CORPORATION
Crystal River Unit 3
Docket No. 50-302
Operating License No. DPR-72

October 22, 1998
3F1098-05

Subject: Low Pressure Injection Engineering Study

**LOW PRESSURE INJECTION
ENGINEERING STUDY**

FIGURE 1
CURRENT LPI CONFIGURATION

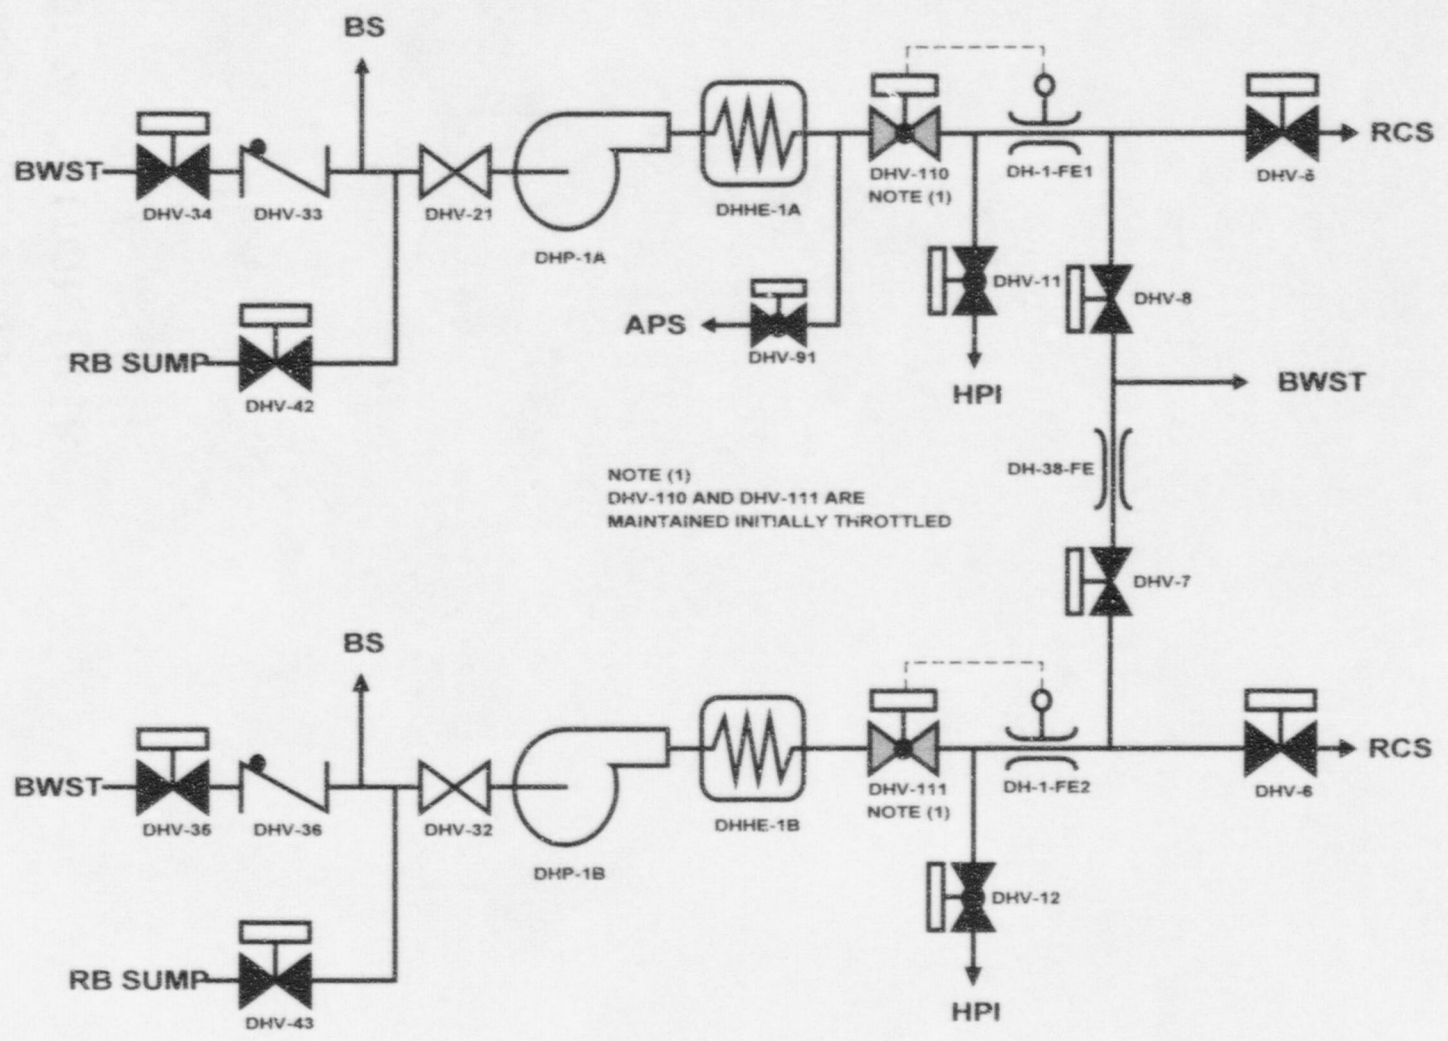
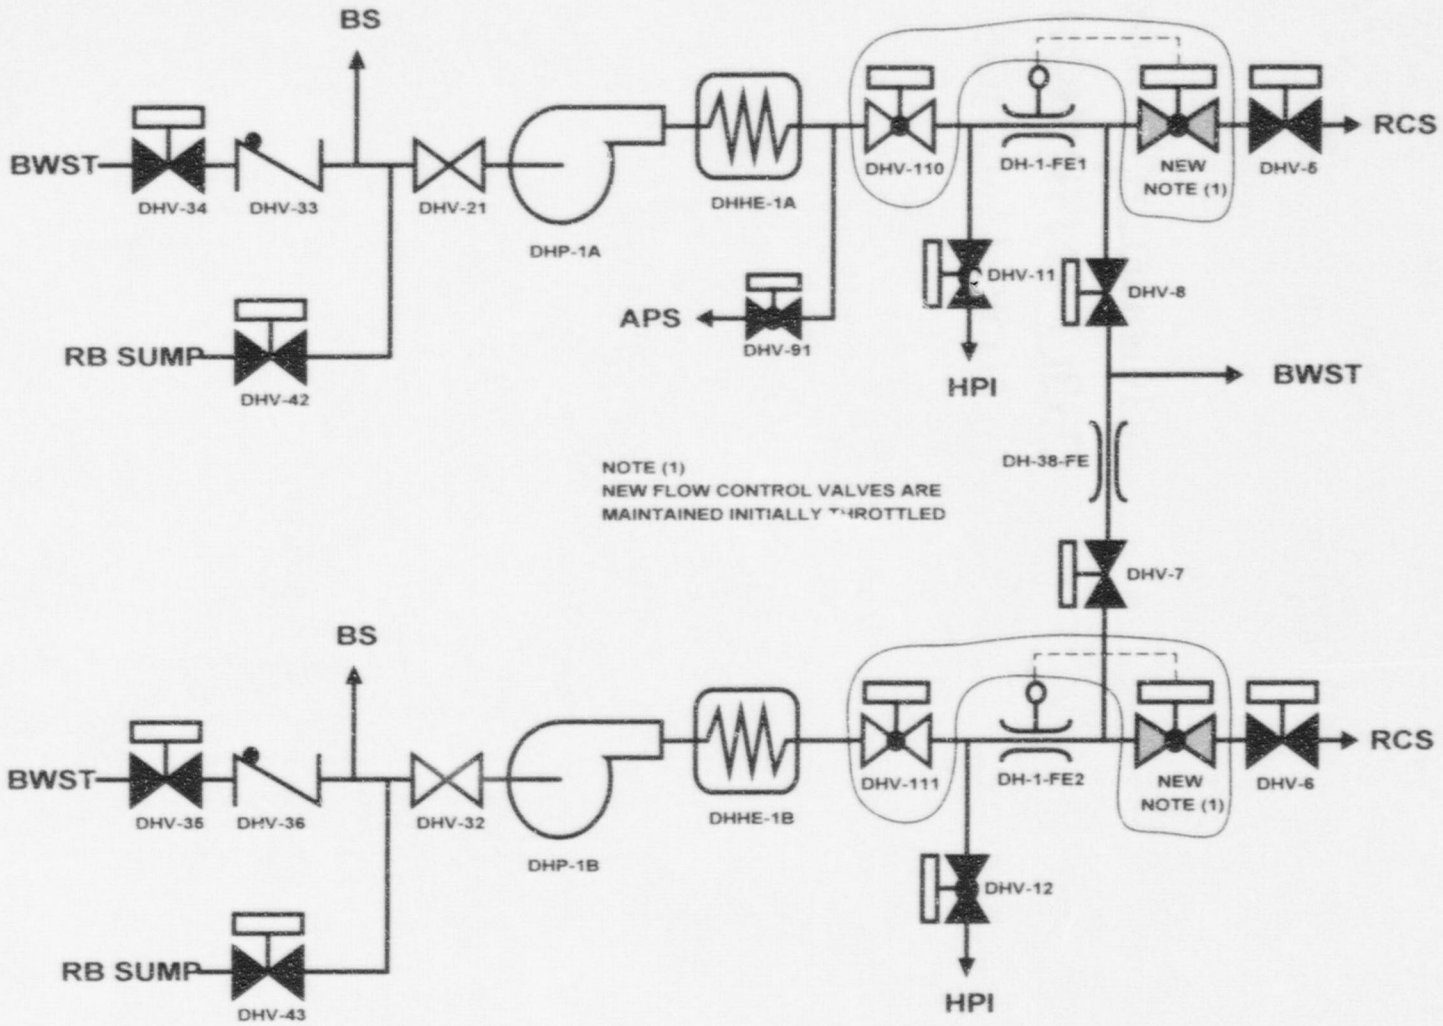
Figure 1 provides a simplified schematic of the LPI system in the normal, standby condition. As shown, the LPI and BS suction valves from the BWST (DHV-34 and DHV-35), and the LPI and BS suction valves from the RB sump (DHV-42 and DHV-43), are maintained normally closed on the suction side of the LPI pumps. The LPI flow control valves (DHV-110 and DHV-111) are maintained throttled at a predetermined position that will ensure adequate, initial LPI injection flow, and the automatic flow controller left in automatic with a selected setpoint of 3000 gpm. The LPI injection valves (DHV-5 and DHV-6), and LPI crossover valves (DHV-7 and DHV-8), are maintained normally closed in the LPI injection flow path. In addition, the LPI to HPI suction valves (DHV-11 and DHV-12), and the auxiliary pressurizer spray (APS) valve (DHV-91) located on train "A" of the LPI system, are maintained normally closed.

Valves DHV-5 and DHV-6 must be manually throttled during LPI/HPI piggyback injection, LPI crossover injection, and transitions between the three emergency operating modes for the LPI system. The throttling service ranges from 500 to 3000 gpm, with a maximum pressure drop across the valve of approximately 180 psi. Valves DHV-5 and DHV-6 are gate valves, and are not specifically designed for throttling service.

Manual throttling of valves DHV-5 and DHV-6 to achieve the desired LPI injection flows is not desirable due to the hydraulic characteristics of the valves. Further, due to the lack of automatic flow control while throttling with DHV-5 and DHV-6, the valves may require continued monitoring and manipulation by the operator as RCS pressure changes.

Figure 2 provides a simplified schematic of the proposed configuration of the LPI system in the normal, standby condition. As shown, two new flow control valves will be added downstream of the LPI crossover line and upstream of valves DHV-5 and DHV-6. The existing flow controls for valves DHV-110 and DHV-111 will be provided to the new LPI flow control valves. The new valves will be normally maintained in a predetermined throttled position that will ensure adequate initial injection flow, with the flow controller set for 3000 gpm and left in automatic.

The existing valves DHV-110 and DHV-111 will be retained, and will normally be left in their full open position. Retaining valves DHV-110 and DHV-111 in the LPI system provides adequate LPI flow control for required surveillance testing and for other normal operations, and provides for isolation of the LPI pumps for conducting maintenance activities.
